Access Compliance Report

Intersection ID: 15095	Main Street: S_LAUREL_AV	Cross Street: WILLOUGHBY_ST	Location: NW
ADA ID: 41B73931FC8F	Ramp Type: PerpDiag	Initial Pass/Fail: Fail	Overall Compliance: No
Severity Score: 13.75			
Codes/Mitigation Info/Possible Solution		Field Measurements/Component Compliance

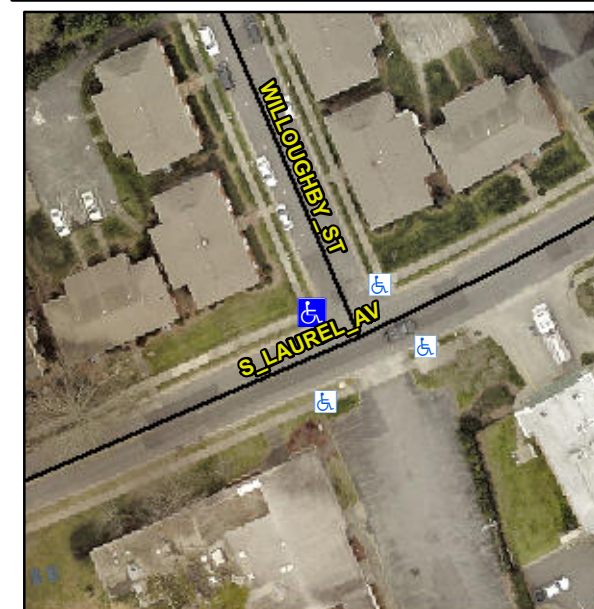
R304.2.2, R304.5.3

Compliance	Description	Data	Compliance	Description	Data
N/A	Ramp Length (in)	73.0	No	Ramp Slope (%)	9.8
Yes	Ramp Width (in)	49.0	No	Ramp XSlope (%)	2.3
N/A	Flare Type LT	N/A	N/A	Flare Type RT	N/A
N/A	Flare Slope LT (%)	N/A	N/A	Flare Slope RT (%)	N/A
N/A	Flare Traversable LT?	N/A	N/A	Flare Traversable RT?	N/A
N/A	Landing Length (in)	N/A	N/A	DWS Provided?	N/A
N/A	Landing Width (in)	N/A	N/A	DWS Contrast?	N/A
N/A	Landing Slope (%)	N/A	N/A	DWS Length (in)	N/A
N/A	Landing X Slope (%)	N/A	N/A	DWS Full Width?	N/A
N/A	Landing Curb? (Y/N)	N/A	N/A	DWS Offset (in)	N/A
N/A	Shared Landing?	N/A			
N/A	Gutter Ponding?	N/A	N/A	Gutter Slope (%)	N/A
N/A	Gutter Lip Ht (in)	N/A	N/A	Gutter X Slope (%)	N/A
N/A	Painted X Walk1?	No	N/A	Painted X Walk2?	No
	X Walk 1 Direction	To S		X Walk 2 Direction	To E
N/A	X Walk 1 Width (in)	N/A	N/A	X Walk 2 Width (in)	N/A
	X Walk 1 Slope (%)	4.6		X Walk 2 Slope (%)	1.5
	X Walk 1 X Slope (%)	4.3		X Walk 2 X Slope (%)	5.0

Remove & Replace Curb Ramp With Two New Directional Ramps or Equivalent.
